ASSESSMENT AGAINST THE APARTMENT DESIGN GUIDE

ATTACHMENT B – CHECKLIST - SEPP 65 Apartment Design Guide (ADG) Checklist
 20 Heradale Parade Batemans Bay

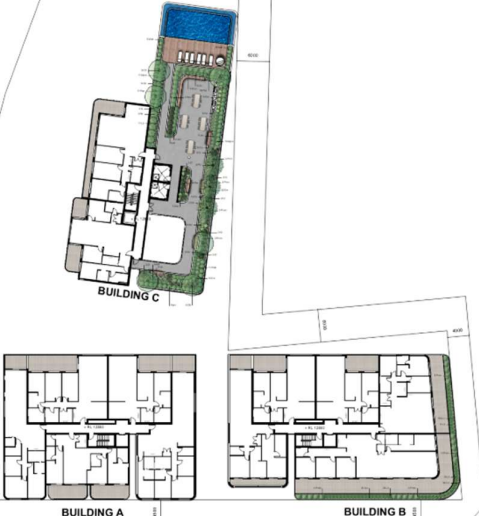
3B – Orientation				
3B-1	Buildings define the street, by facing it, and contain direct access	<input checked="" type="checkbox"/>	<input type="checkbox"/>	<input type="checkbox"/> The site was redesigned during the assessment process to provide improved street access to both street frontages. The applicant provided the following response: <i>significant topography and vegetation to the west. Building orientation and setback arrangements maximise solar access and separation to neighbouring existing residential structures.</i> <i>Site plan</i>

East/west street orientation, rear orientated to the north.	<input checked="" type="checkbox"/>	<input type="checkbox"/>	<input type="checkbox"/> Irregular shaped site.
	North/South street orientation overshadowing should be minimised	<input checked="" type="checkbox"/>	<input type="checkbox"/>	<input type="checkbox"/>

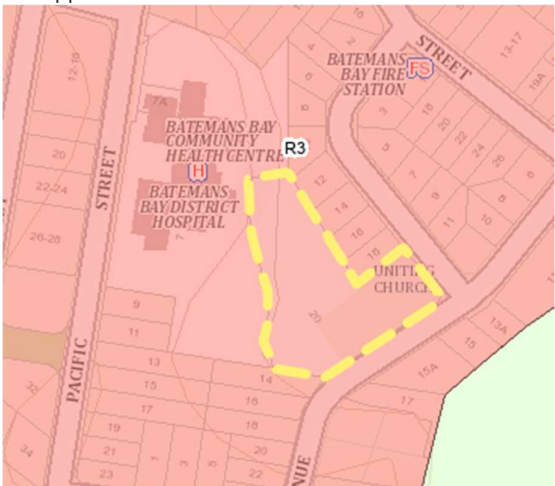
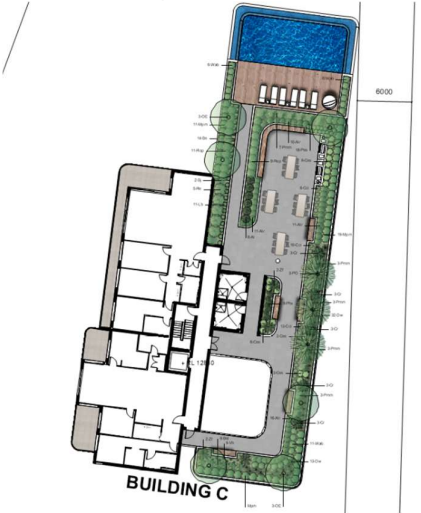
TREES AND VEGE TO REMAIN

REFER CONDITIONS OF COVENANT - TREE RETENTION AND SITE PLAN - TREES TO BE RETURNED IN VICINITY OF BUILDING WORKS

VIEW FROM HAREDALE PARADE

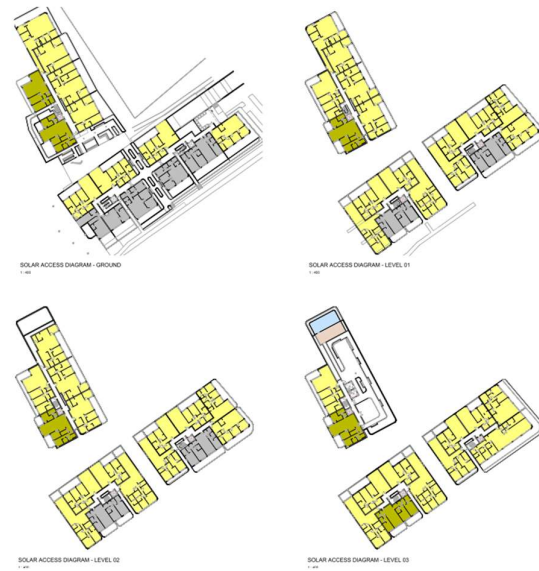
3H – Vehicle Access					
3H-1	Car park access should be integrated with the building's overall façade. Design solutions may include: <ul style="list-style-type: none"> - The materials and colour palette to minimise visibility from the street - Security doors or gates at entries that minimise voids in the façade - Where doors are not provided, the visible interior reflects the façade design and the building services, pipes and ducts are concealed. 	<input checked="" type="checkbox"/>	<input type="checkbox"/>	<input type="checkbox"/>	Set back behind building line.
	Car park entries should be located behind the building line	<input checked="" type="checkbox"/>	<input type="checkbox"/>	<input type="checkbox"/>	
	Vehicle entries should be located at the lowest point of the site minimizing ramp lengths, excavation and impacts on the building form and layout	<input checked="" type="checkbox"/>	<input type="checkbox"/>	<input type="checkbox"/>	Located away from the main street – Bavarde Avenue and away from the corner location.

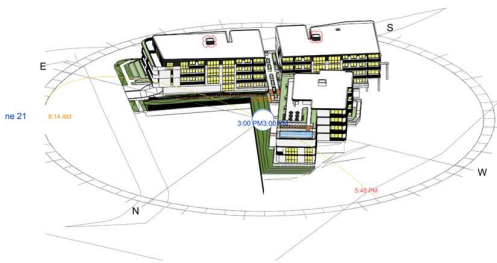
Residential Flat Building	1 bedroom	1 space per unit																							
	2 or more bedrooms	2 spaces per unit																							
2 x 1 bed =	2 spaces																								
58 x 2 + bed units =	116 spaces																								
	Total 118 spaces																								
Metropolitan sub-regional centres unit																									
2 x 0.6 spaces per 1 bedroom	1.2																								
12 x 0.9 spaces per 2 bedroom unit	10.8																								
46x 1.40 spaces per 3 bedroom unit	64.4

<table><tr> <td>TOTAL</td><td>76.4 (77) spaces</td></tr><tr> <td>Total required</td><td>89 spaces</td></tr><tr> <td>Provided:</td><td>91 spaces (including car wash bays) or 88 spaces (residential/visitor)</td></tr></table>

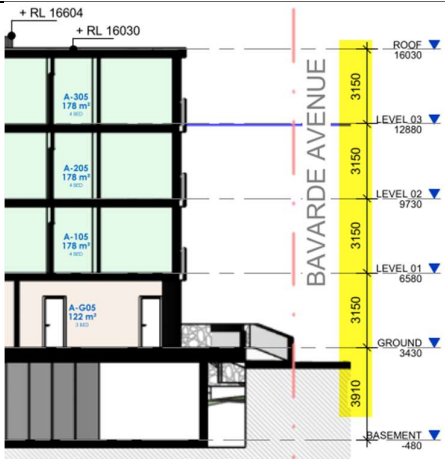
A max, of 15% of apartments receive no direct sunlight between 9&3	<input checked="" type="checkbox"/>	<input type="checkbox"/>	<input type="checkbox"/>	<div><div><div><div>SOLAR ACCESS</div>

</div><div><p>Solar matrix provided.</p><p>Meets: Objective 4A-1 <i>To optimise the number of apartments receiving sunlight to habitable rooms, primary windows and private open space</i></p></div></div></div>	UNITS SOLAR ACCESS	COUNT	PERCENTAGE	3 HOURS	45	75%	NO SOLAR	9	15%	PARTIAL SOLAR	6	10%		60	
UNITS SOLAR ACCESS	COUNT	PERCENTAGE																	
3 HOURS	45	75%																	
NO SOLAR	9	15%																	
PARTIAL SOLAR	6	10%																	
	60																		
The design maximises north aspect and the number of single aspect south facing apartments is minimised	<input checked="" type="checkbox"/>	<input type="checkbox"/>	<input type="checkbox"/>	<div><p>View from sun diagrams illustrate sunlight provision to the different buildings throughout the day</p></div>															
Single aspect, single storey apartments should have a northerly aspect	<input checked="" type="checkbox"/>	<input type="checkbox"/>	<input type="checkbox"/>	Configuration and apartment mix allows for mix aspect and corner units.															
Living areas are best located to the north and service areas to the south and west of apartments	<input checked="" type="checkbox"/>	<input type="checkbox"/>	<input type="checkbox"/>																
To optimize the direct sunlight to habitable rooms and balconies a number of the following design features are used: <ul style="list-style-type: none">- Dual aspect apartments- Shallow apartment layouts- Two storey and mezzanine level apartments- Bay windows	<input checked="" type="checkbox"/>	<input type="checkbox"/>	<input type="checkbox"/>	Dual aspect and cross-ventilation areas maximised due to 3 x building utilised on the site.															
To maximise the benefit to residents of direct sunlight within living rooms and POS, a minimum of 1m2 of direct sunlight, measured at 1m above floor level is achieved for at least 15 minutes	<input checked="" type="checkbox"/>	<input type="checkbox"/>	<input type="checkbox"/>																
Achieving the design criteria may not be possible on some sites. This includes: <ul style="list-style-type: none">- Where greater residential amenity can be achieved along a busy road or rail line by orientating the living	<input checked="" type="checkbox"/>	<input type="checkbox"/>	<input type="checkbox"/>	Consideration being given to amenity and road noise via acoustic treatments in façade. The site location allows for apartments to be oriented to receive sufficient views and solar access.
